REMARKS

U.S.S.N. 10/057,026

FIG. 1L

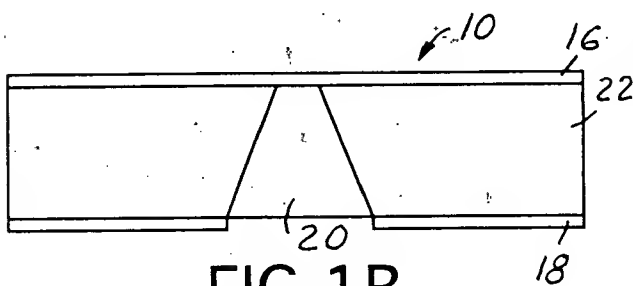
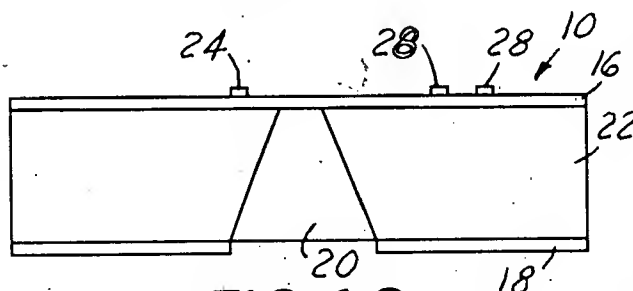
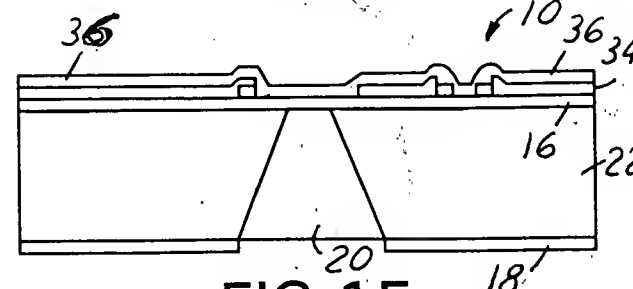
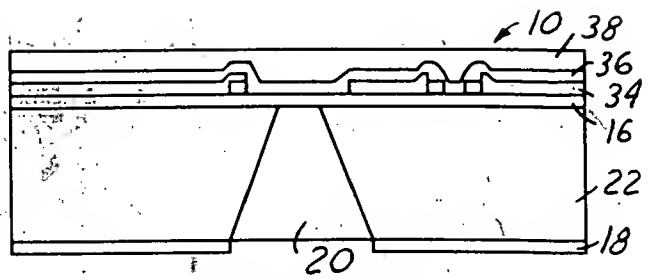
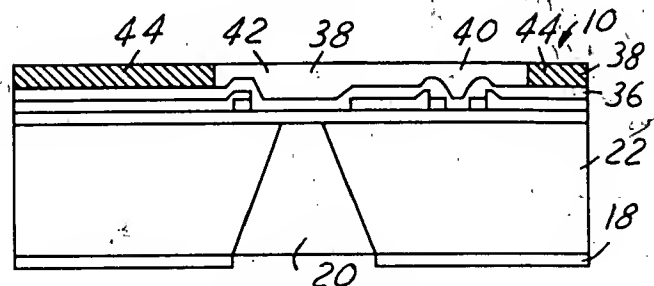
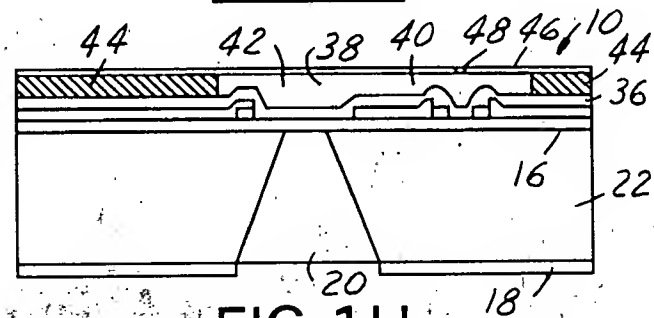
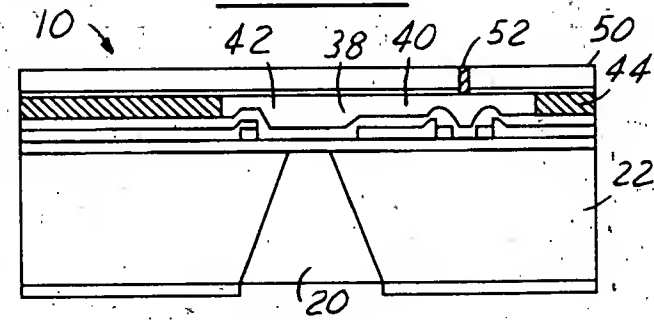
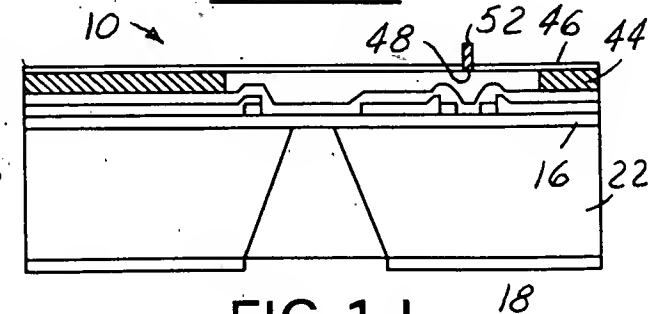
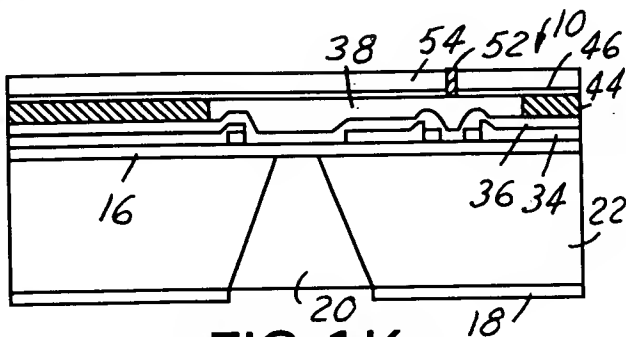
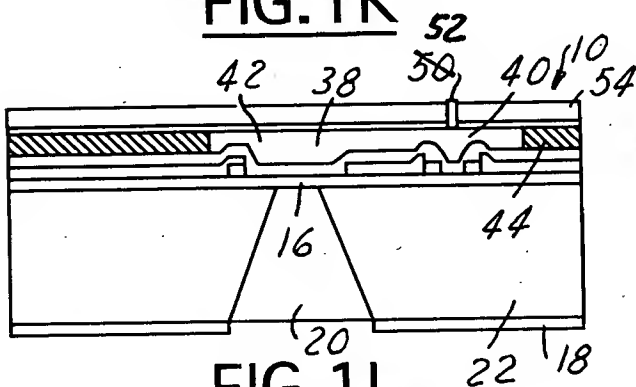
The drawings are objected to for not showing the first and the second insulating material layer. The Applicants respectfully point out that throughout Figs. 1B~1L, both reference numerals 16 and 18 have been shown to designate the top and the bottom insulating material layer.

It is pointed out that claims 11 and 14 are unclear because it merges elements of the intermediate structure shown in Fig. 1L with the final structure shown in Fig. 3F.

The Applicants respectfully submit that point out that while Figs. 1A-1N are cross-sectional views illustrating the fabrication process for the present invention ink jet, Figs. 3A-3F are all the same figures similar to Fig. 1N. The purpose of Figs. 3A-3F is to illustrate the working or the functioning of the present invention inkjet device. Figs. 3A-3F are not shown to illustrate the fabrication process of the device.
